ASSESSMENT REPORT

HOLCIM REGIONAL DISTRIBUTION CENTRE, ROOTY HILL Rail Delivery and Infrastructure Re-Configuration Modification (MP 05_0051 Mod 1)

Figure 2: Proposed Modifications to the Project Layout

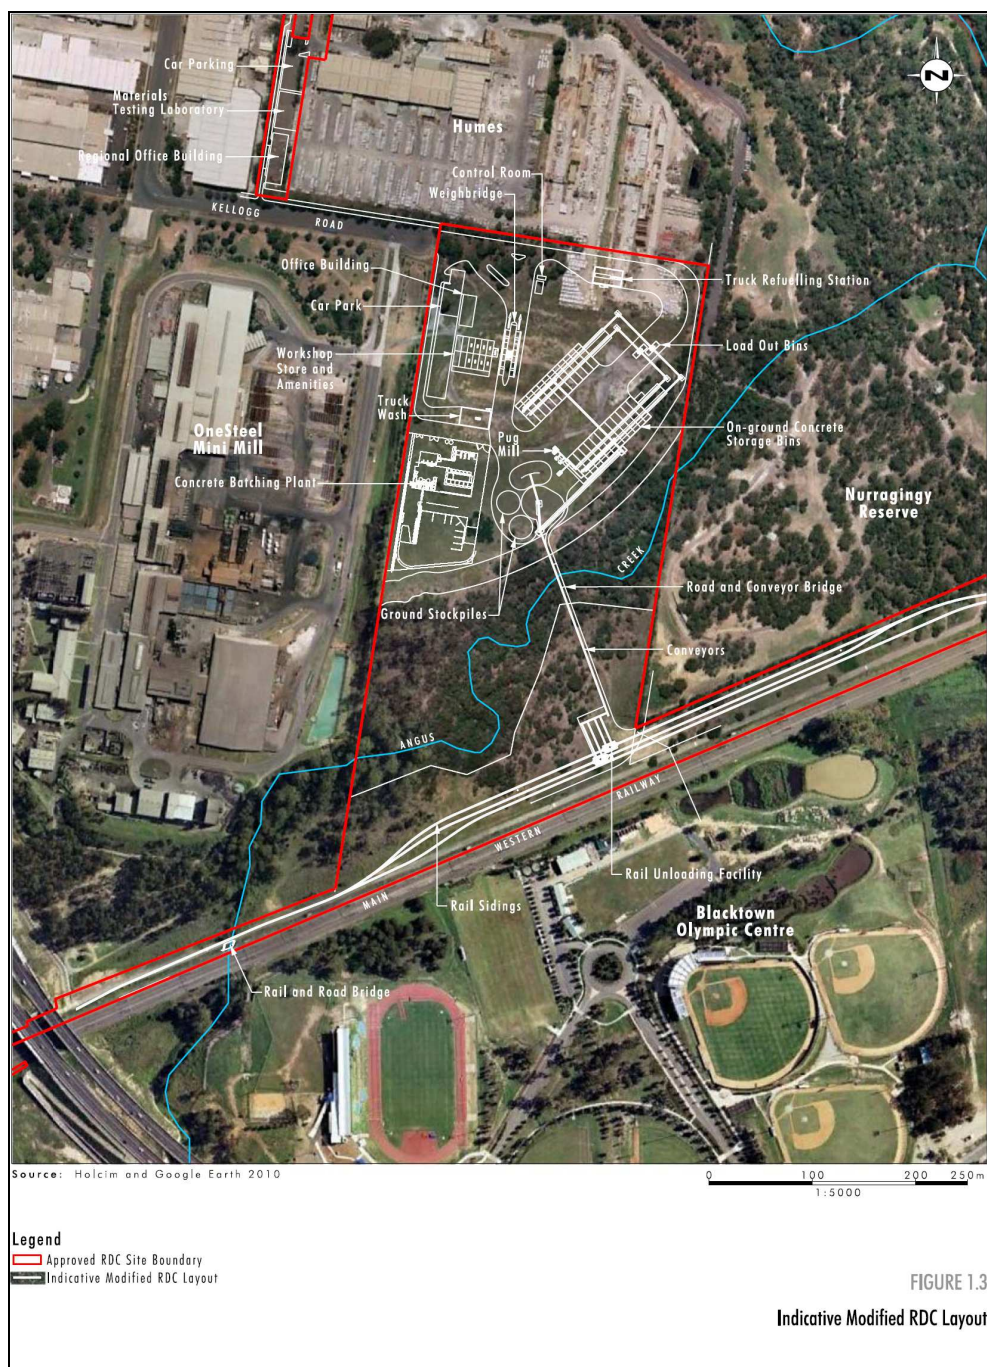
- reconfiguring the rail siding adjacent to the Main Western Rail Line to reduce the length and number of sidings;
- reducing the payload capacity of trains, and increasing the average number of train deliveries from 4 to 4.5 per day for the initial phase of development;
- altering the configuration and location of the rail unloading facilities;
- increasing the ground storage area adjacent to the radial stacker;
- converting the elevated steel storage bins to on-ground concrete storage bays;
- removing the ground storage bins located west of the elevated steel storage bins;
- closing North Parade in lieu of relocating the road; and
- reconfiguring the office, workshop and other internal facilities to improve operational efficiencies.

Table 1 below provides a comparison of the approved project and the proposed modified project. The proposed modifications are depicted in **Figure 2** below, and are described in full in the *Proposed Minor Modification to Holcim Regional Distribution Centre (RDC), Rooty Hill Environmental Assessment*, prepared by Umwelt (Australia) Pty Limited (Umwelt) and dated October 2010.
